Subject: RATTLE / CHATTER TYPE NOISE FROM A/C VENTS WHEN DRIVING ON ROUGH ROAD SURFACE	Bulletin No: 09-028/16
	Last Issued: 04/29/2016

2016 CX-3 vehicles with VINs lower than JM1 DK ***** 109815 (produced before July 14, 2015)

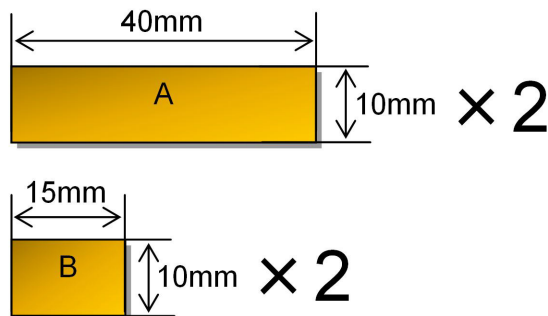
Some vehicles may exhibit a rattle/chatter type noise from the A/C vents when driving on an uneven/rough road surface.

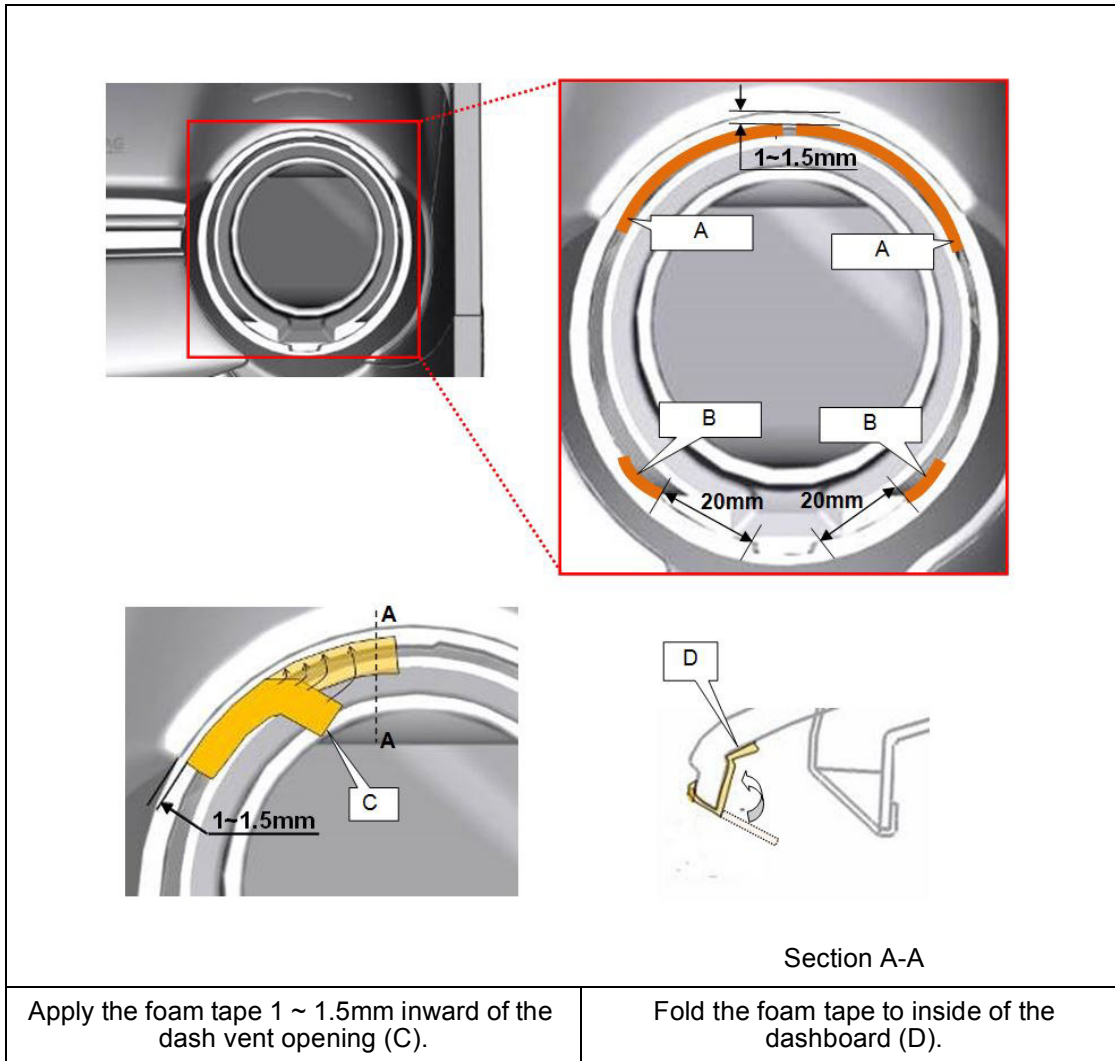
1. Verify customer concern.
2. Remove the affected ventilator grille(s) (A/C vents). Refer to MS3 online "VENTILATOR GRILLE REMOVAL/INSTALLATION".
3. Cut the foam tape from the Noise Repair Kit (P/N TA01-76-100) to the following shapes.

4. Apply the foam tape from the previous step to the following positions of the dashboard.

5. Install new ventilator grille(s). Refer to MS3 online “VENTILATOR GRILLE REMOVAL/INSTALLATION”.
6. Verify repair.
